## **Addendum No. 2**

March 8, 2023

**Construction WWTP Locker Room Upfit  
North Charleston Sewer District  
North Charleston, SC**

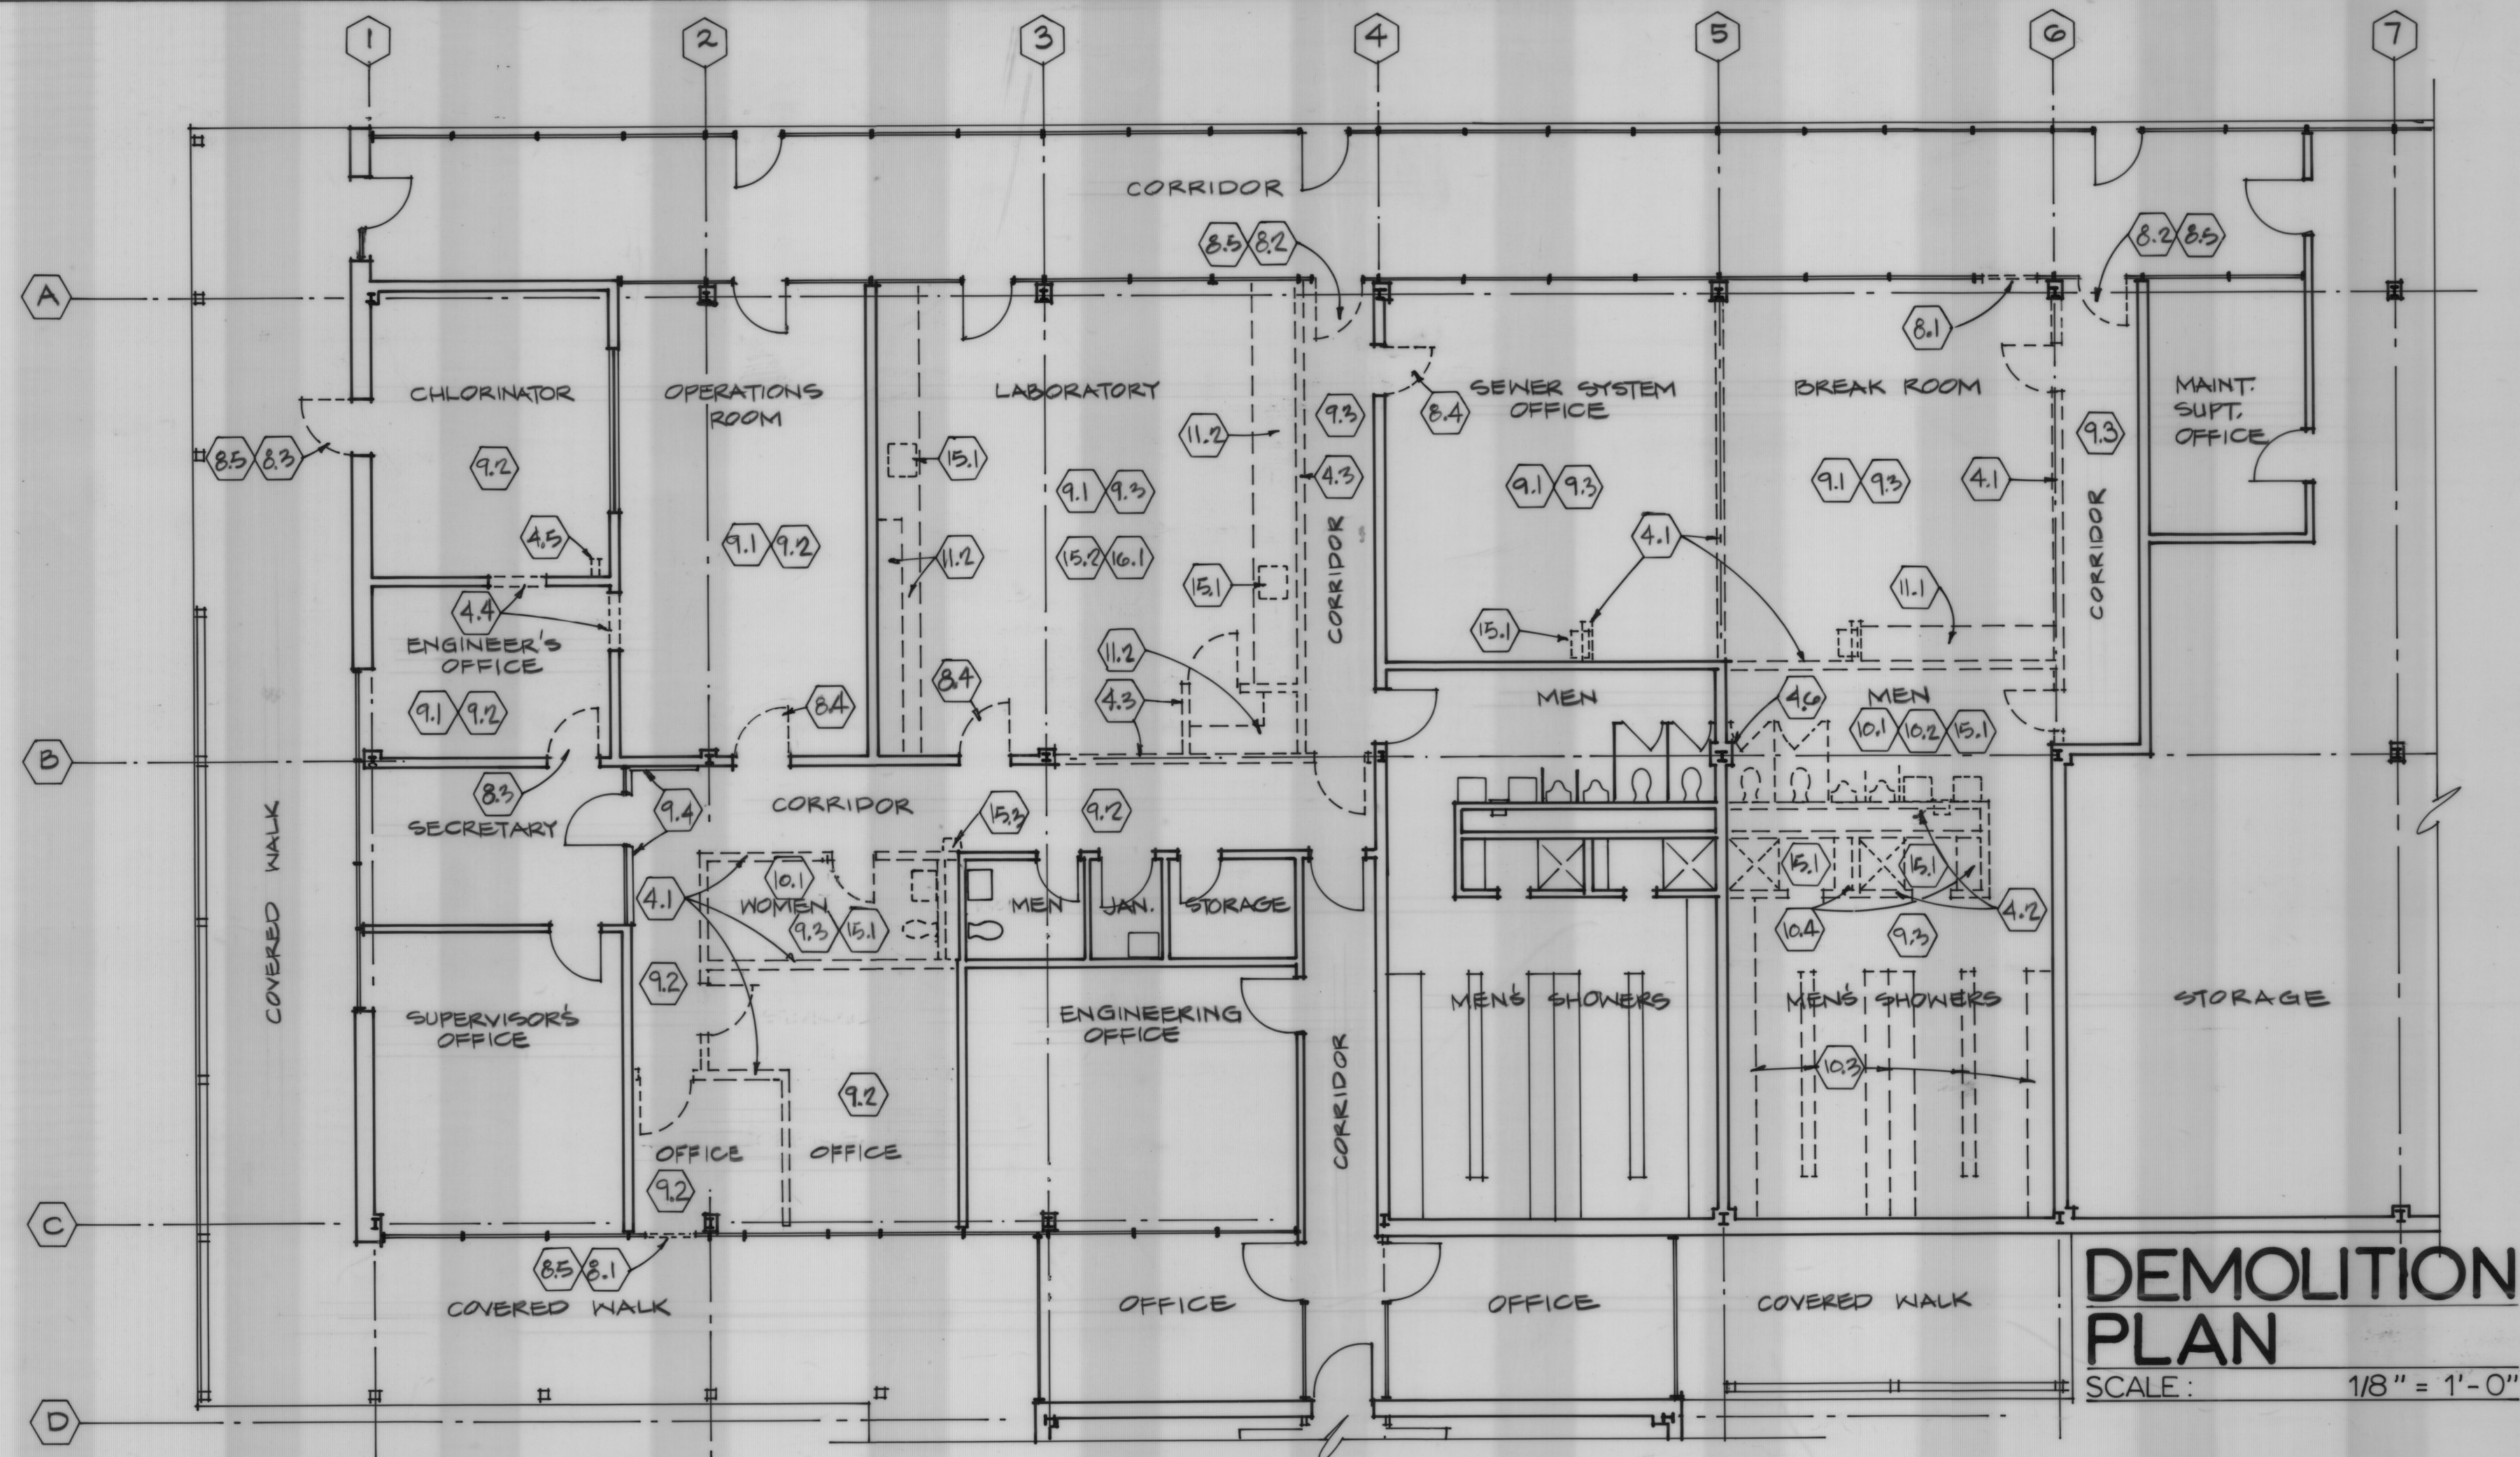
7. Question 7: Please provide dimensions of existing lockers.

Answer: Please see the attachment for existing locker dimensions. **NOT TO SCALE**
